DISCRETIONARY REVIEW ANALYSIS

Record No.: 2021-009470DRP
Project Address: 4820 Anza Street
Permit Application 2021.0830.7438
Zoning: RH-2 [Residential House- Two Family]
Family Housing Opportunity SUD
40-X Height and Bulk District
Cultural District: NA
Block/Lot: 1505 / 016
Project Sponsor: Fiona Lee
Inncon Design
3626 Geary Blvd. Suite 203
San Francisco CA 94118
Staff Contact: David Winslow – (628) 652-7335
david.winslow@sfgov.org
Environmental Review: Categorical Exemption

Recommendation: Take DR and Approve with Modifications

Figure 7. Proposed Two-Story Addition and Roof Deck location in relation to the Katz's home.

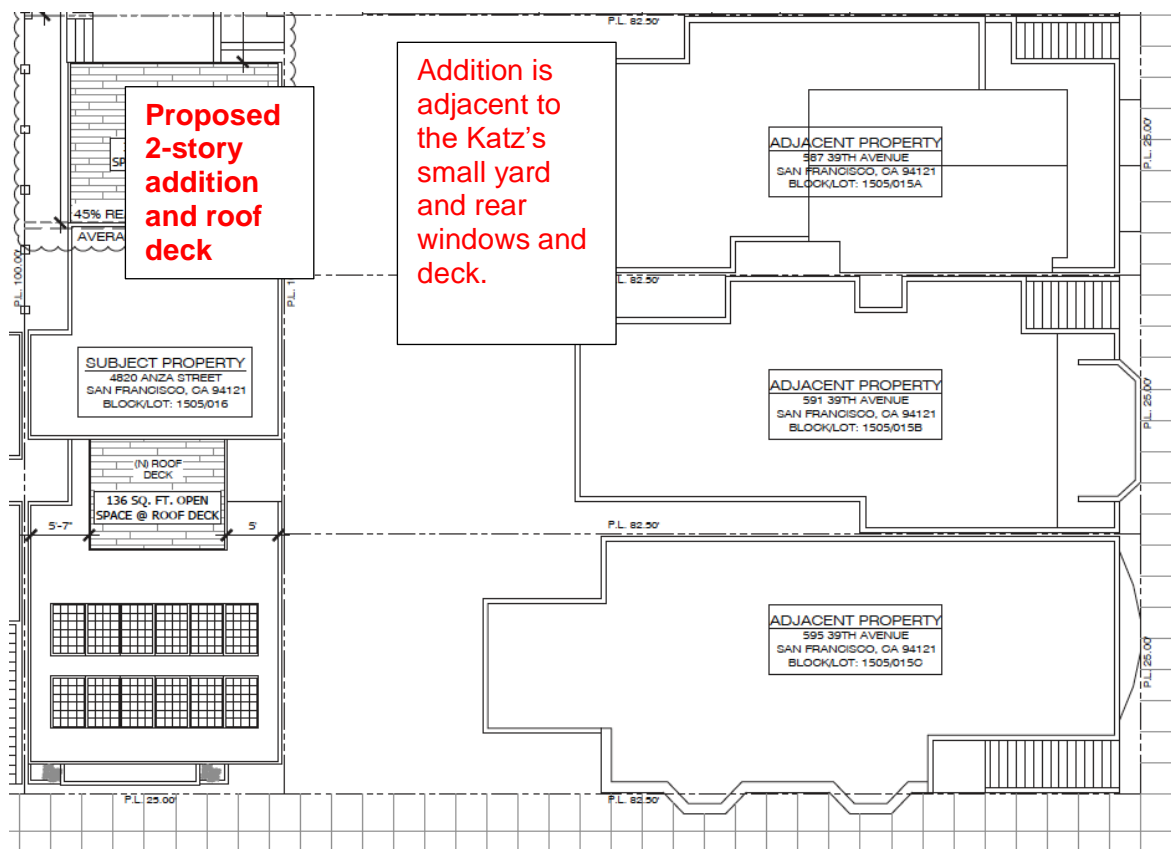
The project would substantially impact the Katz’s privacy due to the addition of a new roof deck and third and fourth story east-facing windows that will allow future occupants to look into their rear deck and bedroom windows. See Figures 7 and 8 below.

Figure 9. 4820 Anza 2023 Red outline shows rear addition.

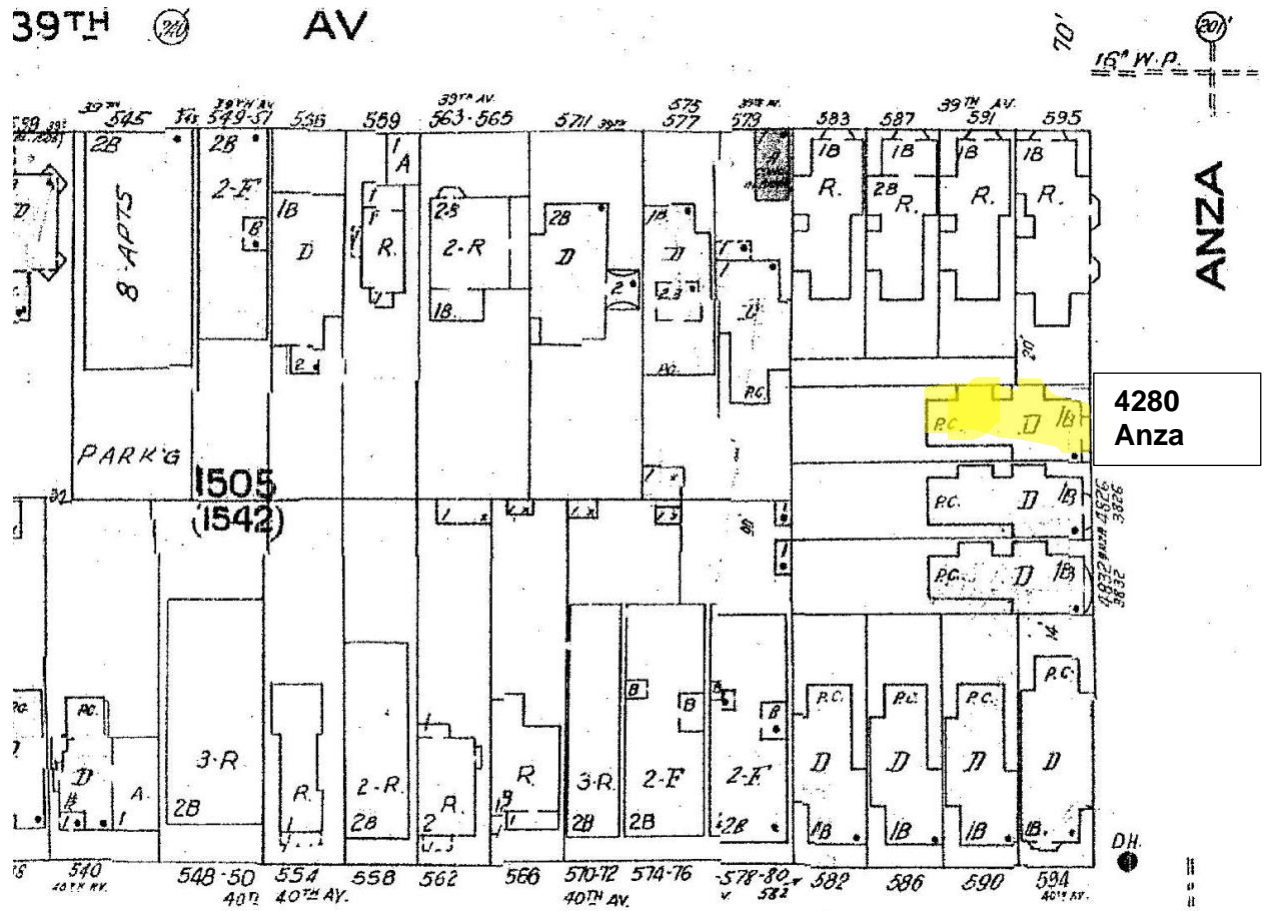
A comparison of the 2023 aerial photo below in Figure 9 and the Sanborn Map from the mid-1990s (Figure 10), an addition to the rear of the home was made sometime after the mid 1990s.

Figure 11. Remove Proposed 4th Floor and Rear Roof Deck

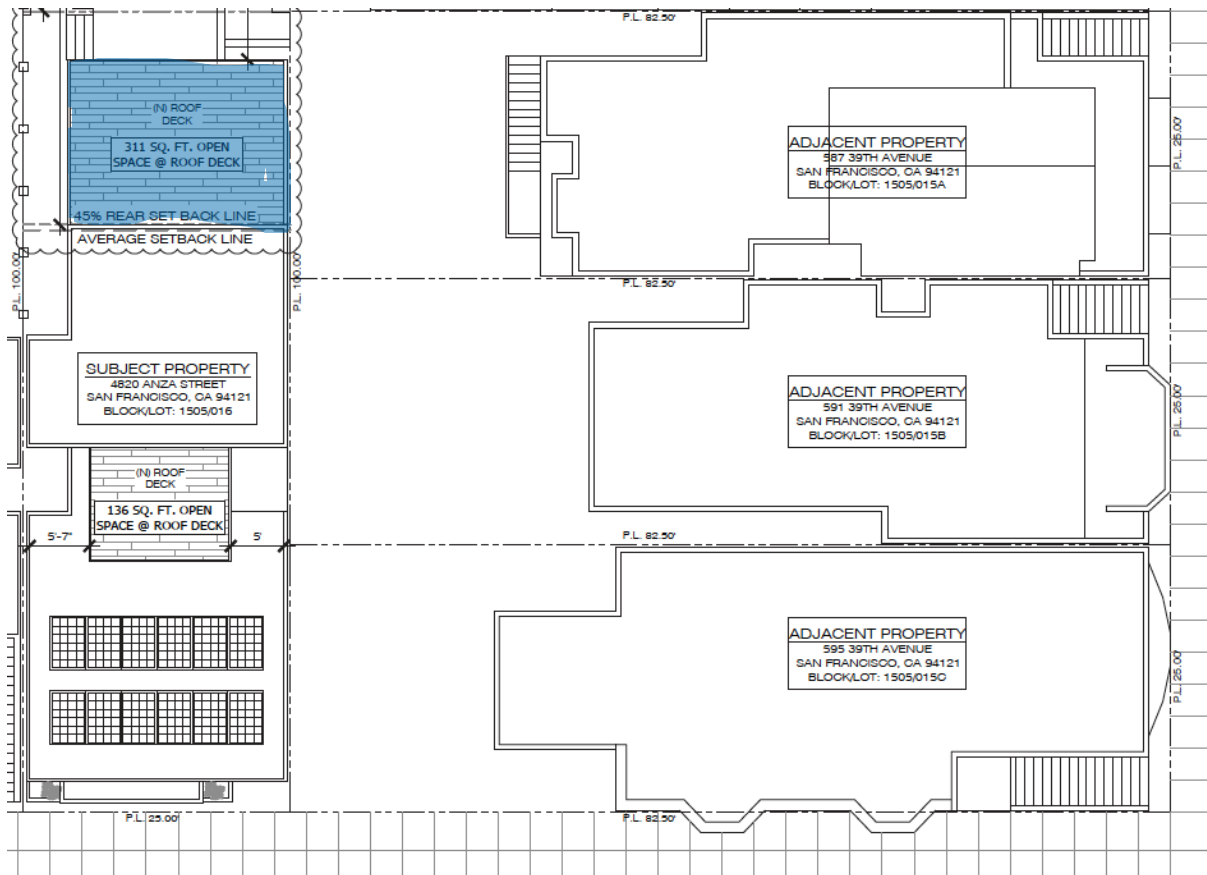
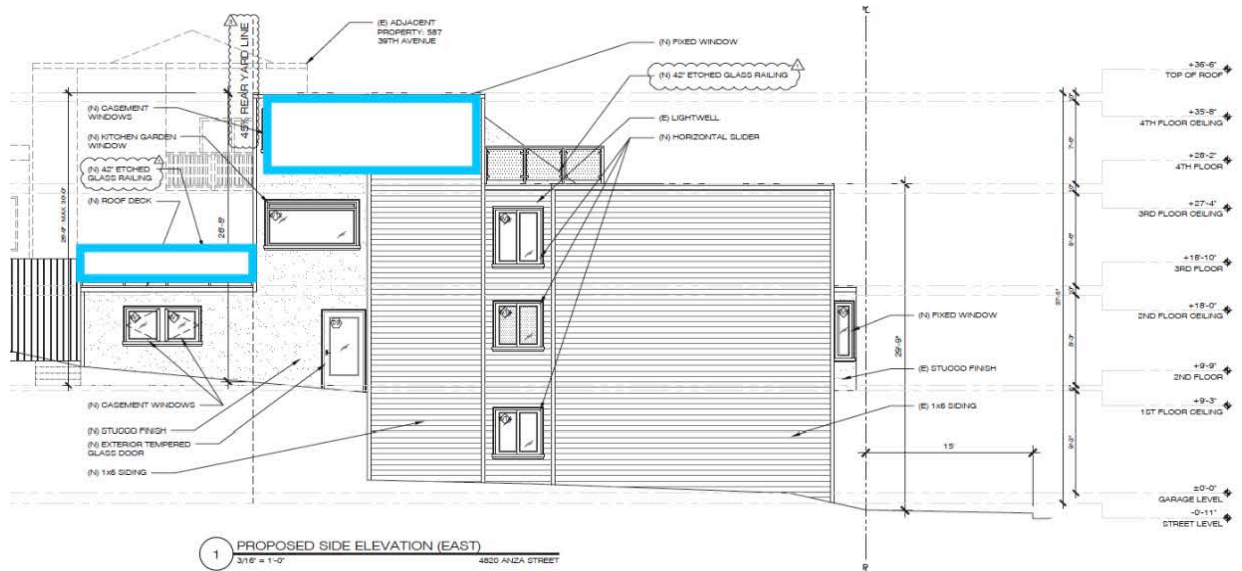
No changes have been made by the project sponsor in response to the Katz's or other neighbors' concerns. In order to reduce the significant shadow, privacy, and other impacts associated with the massing that is out of scale with the neighborhood, the plans should be modified as follows and shown in Figure 11 below:

1. Eliminate the proposed fourth story.
2. Eliminate the rear roof-deck.
